SUNNICA ENERGY FARM - DCO APPLICATION

REVIEW OF NOISE IMPACTS ON THE HERMES CAMPUS

Acoustics Report A1921 R03C

11th November 2022

Figure 1 – Site and Surroundings

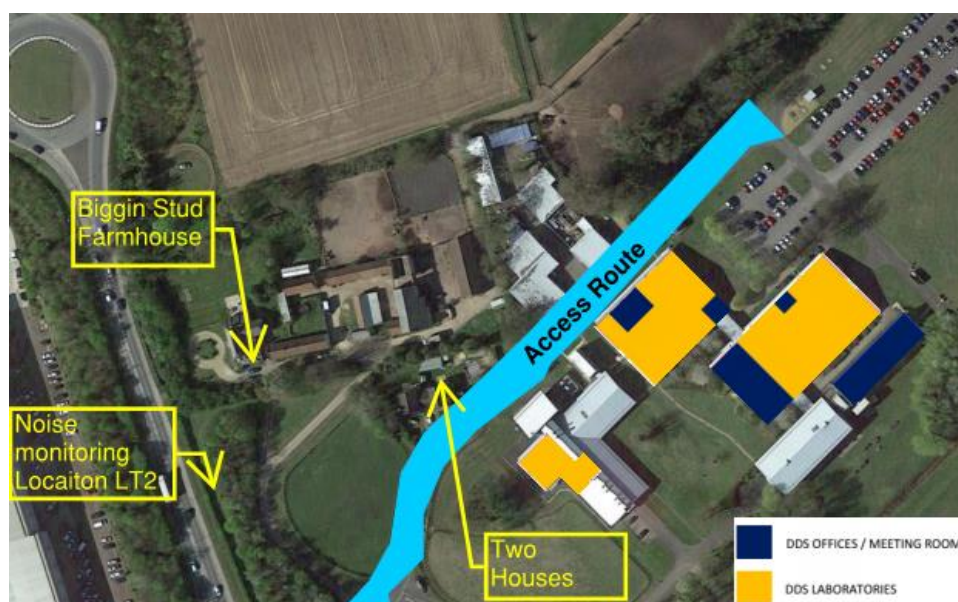
- 3.1.2 Receptor R3 is labelled Biggin Stud Farmhouse (See Figure 1). A noise monitoring exercise was carried out by AECOM at position LT2 to established baseline noise levels in the area.

- 3.1.3 Although the exact location is not clearly identified in the ES, monitoring position LT2 was at the side of Newmarket Road. A location adjacent to Newmarket Road would have far higher road noise levels than at Biggin Stud Farmhouse (Receptor R3) or the laboratories. The monitoring location is therefore not representative of noise levels at the Campus and is an unreliable baseline on which to assess the noise impact on the campus.

Figure 3 – Vibration Criteria (VC) curves for different instruments from Gordon, C "Generic Vibration Criteria for Vibration-sensitive Equipment" SPIE 1999

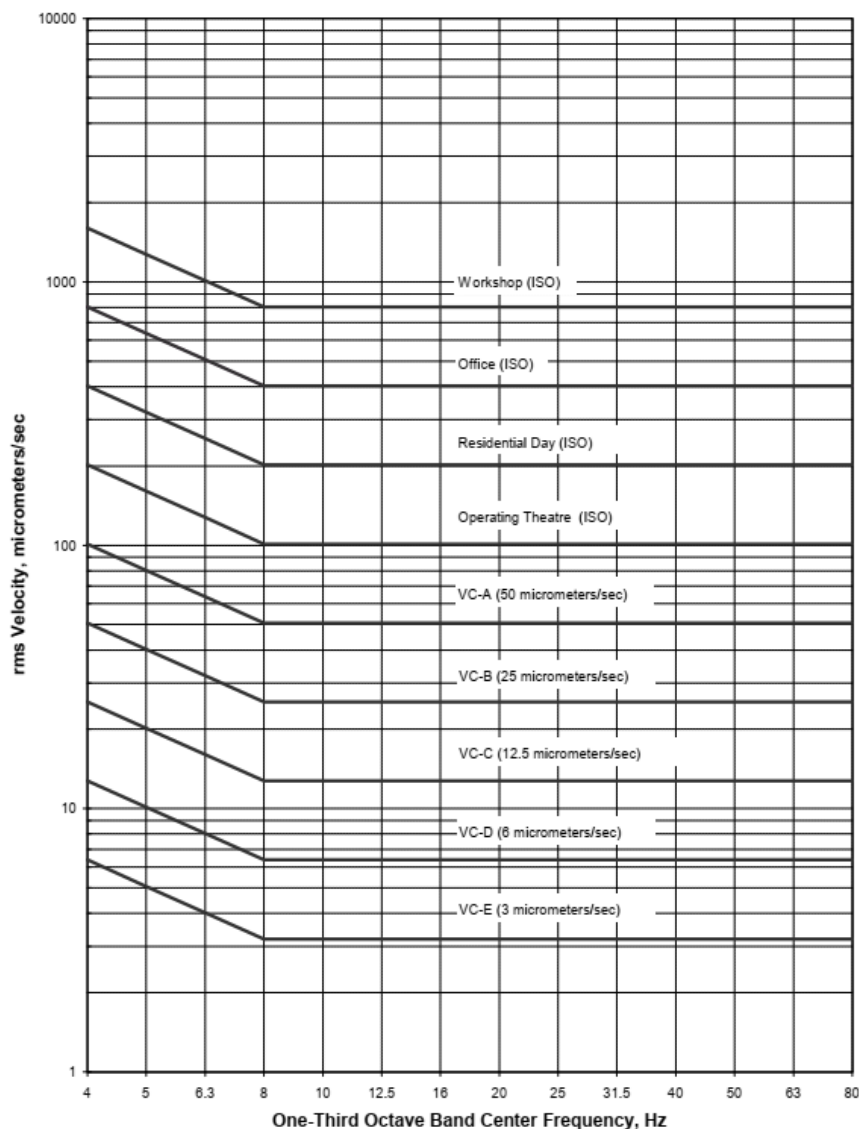
4.3.4 We are informed that the maximum vibration level that can be tolerated by instruments at the Campus is VC-B. This would apply on the floor of the laboratories. It can be seen in Figure 3

that this threshold is considerably more demanding than the thresholds for human perception in office and residential environments.

- 4.3.5 This is a very low vibration limit of 0.025 mm/s. When this level is exceeded, there is a risk of inaccurate readings from the various laboratory equipment and any scans would have errors.
- 4.3.6 Therefore, even one exceedance of this level is sufficient to disrupt the activity and this could be caused by a single HGV. A detailed vibration assessment should have been carried out to determine the effect of vibration on the laboratories and their equipment. There is no such assessment in Sunnica's ES.
- 4.3.7 British Standard BS 5228-2: 2014+A1:2019 provides some information to predict vibration levels from construction. Various equations are given for impact piling, vibratory piling and dynamic compaction (eg using vibrating rollers). The appropriate equation for (steady-state) vibrating rollers is:
